**Response to NRC Request for Additional Information
RAI 315, Question 03.07.02-64 (Part C)
Seismic System Analysis,
Calvert Cliffs Nuclear Power Plant, Unit 3**

RAI No. 315

Question 03.07.02-64

**Changes to CCNPP Unit 3 COLA Associated with the
Response to RAI 315, Question 03.07.02-64 (Part C),
Calvert Cliffs Nuclear Power Plant, Unit 3**

FIGURE 1
AXES CONSIDERED FOR OVERTURNING ANALYSIS

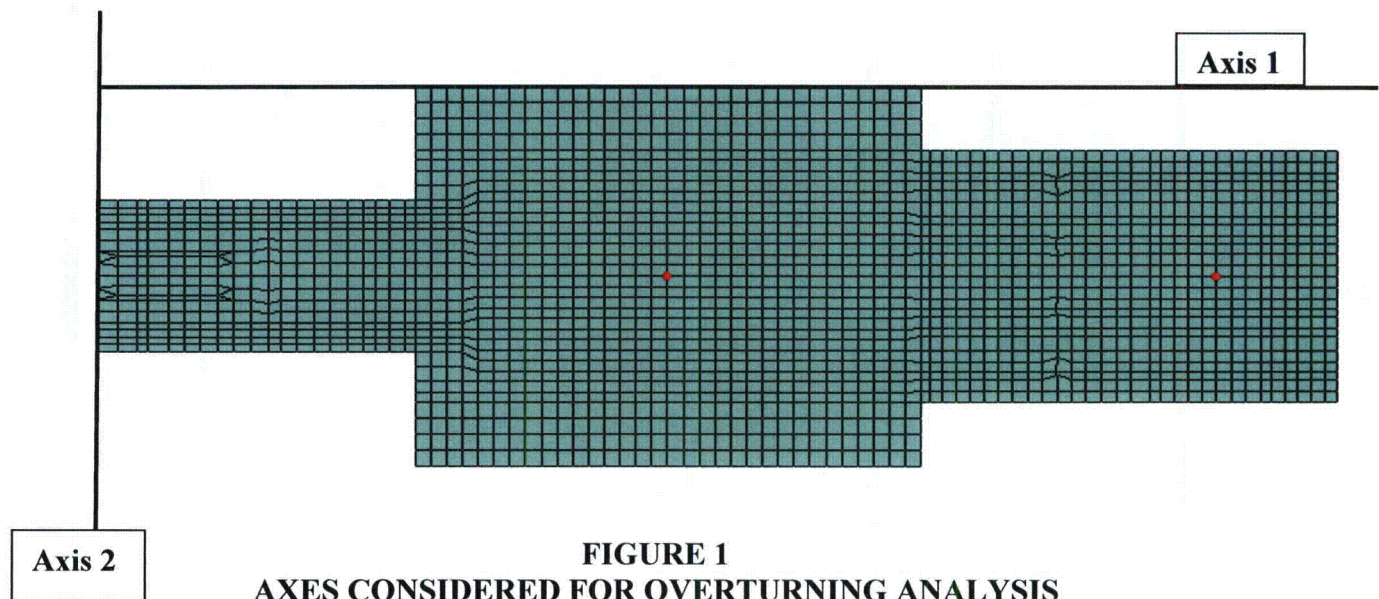
- C. In RAI 304, Question 03.07.02-61, the staff has asked for information regarding the stability of the Common Basemat Intake Structure (CBIS). Based on the response to RAI 253, Question 03.07.02-49 the staff requires additional information as follows: In the portion of its

response that addresses static and dynamic lateral earth pressures, the applicant states that the static and dynamic earth pressures along the embedment depth were not considered in the sliding and overturning factor of safety and the seismic stability evaluation was performed using only the dynamic and static stresses at the interface between the foundation mat and the soil. However, based on note 1 in FSAR Table 3.8-2 providing the stability results for the CBIS, it appears that friction between the side walls and backfill is used in the stability load combinations which include earthquake. FSAR Table 3.8-1 provides a static coefficient of friction of 0.52 between the CBIS sidewall and structural fill. Since it is not clear how the sliding factor of safety was determined the staff requests the applicant provide for the CBIS, information similar to what is requested in Part A above for the EPGB and ESWB.

5. For the overturning analysis, the static restoring vertical stresses and seismic driving vertical stresses are considered. Conservatively, the effect of lateral passive earth pressures is not accounted for in the overturning analysis. Seismic active earth pressures are considered as additional driving stresses for the sliding and overturning analyses, and they are determined based on Mononobe-Okabe method (Kramer 1996).

Overturning moments are calculated at Axes 1 and 2 as shown in **Figure 1**. Overturning is more likely to occur around Axis 1. However, for the completeness of the analysis, a factor of safety is also calculated for Axis 2.
